SUBJECT: NHTSA Recall No. **09V-021**
Transport Canada Recall No. **09-011**

CONCERN: Torque values on all Telma Retarder installation fasteners.

Subject: Telma Retarder Installation

NEXT ASSEMBLY: NONE	DRAWING INFORMATION				TITLE:			
SUPERCEDES: NONE	DRAWN: RYSER	CKD:			TORQUE SPECS, DRIVELINE & TELMA			
DO NOT SCALE DRAWING	DATE: 10/15/08	SIZE: A			MATERIAL SPEC:			
MARK PART NUMBER AND REVISION ON ALL PARTS	SCALE: 1/24	WGT:			PART NUMBER			
THIS DRAWING IS THE PROPERTY OF EL DORADO NATIONAL COMPANY, A THOR INDUSTRIES COMPANY AND IS NOT TO BE DUPLICATED OR USED IN ANY WAY DETRIMENTAL TO THEIR BEST INTEREST. REV. 02/02	TOLERANCE UNLESS SPECIFIED				RELEASE TO PRODUCTION			
	FRACTIONS $\pm 1/16$	DECIMALS $\pm .06$	ANGLES $+ 1 \text{ DEG.}$		13634	RELEASE #		
	REV.	BY	DATE		DESCRIPTION			
						0032960		PAGE 1 OF 2

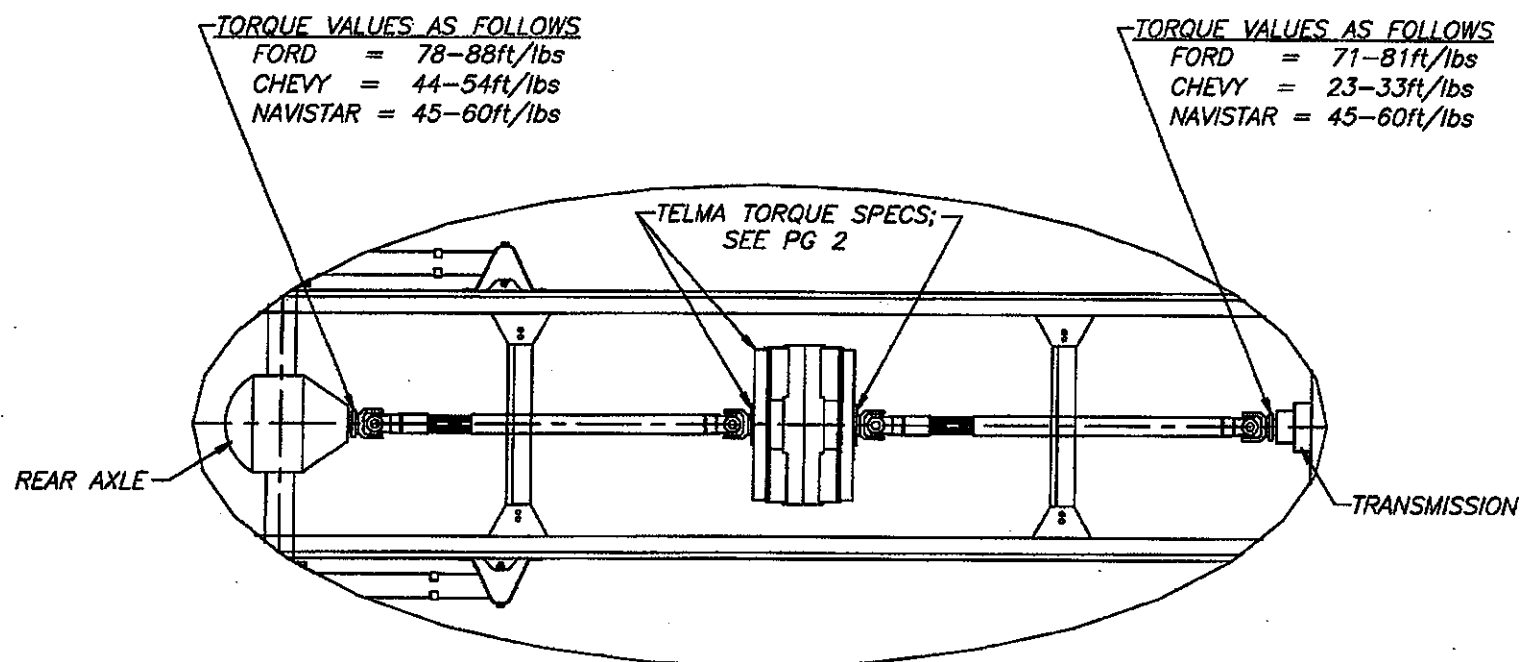
SOLUTION: Check all fasteners to insure proper torque has been applied on both the fasteners securing the driveline & mounting brackets as outlined by ElDorado National's print p/n 0032960.

- TIR03109 relay box
- bracket
- mounts using chassis bracket bolts
- TIR03109
- 9/16" BOLTS: 150 LB-FT
- TIR03121 DRIVER (LEFT) SIDE
- 150 LB-FT
- 65 LB-FT
- TIR03122 PASSENGER (RIGHT) SIDE
- 3/8-24UNF FLANGE YDKE (INDEX 158)
- NUT TORQUE 40-48 LB-FT

USE MEDIUM STRENGTH LOCTITE ON ALL
FASTENERS AND MARK WITH PAINT
AFTER TIGHTENING TO PROPER TORQUE
